**NORTHERN VIRGINIA STREAM RESTORATION BANK
THE GLADE - REACH 5**
Fairfax County, Virginia

PRELIMINARY PLAN

Sheet #
4 of 4

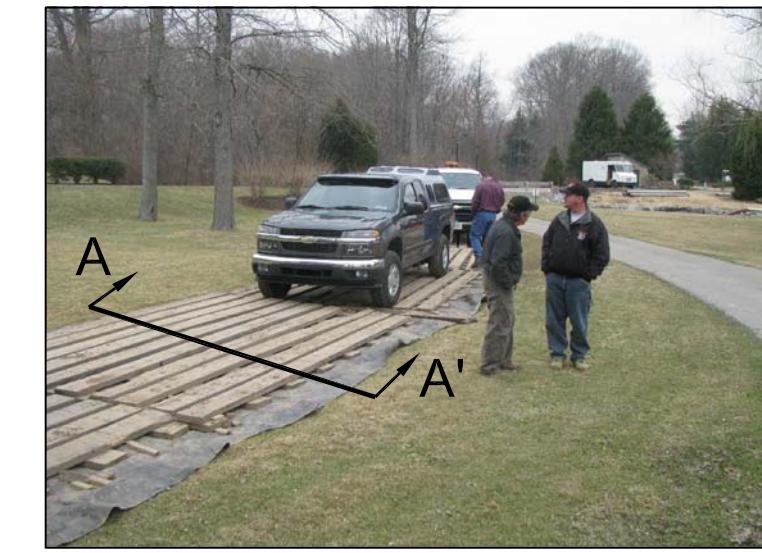
STREAM REALIGNED
AWAY FROM TRAIL

MOVE LOG INTO
FLOODPLAIN AND
SECURE WITH DUCKBILL
ANCHORS.

REVISED LIMITS OF
CLEARING AND
TEMPORARY ACCESS
PATH.
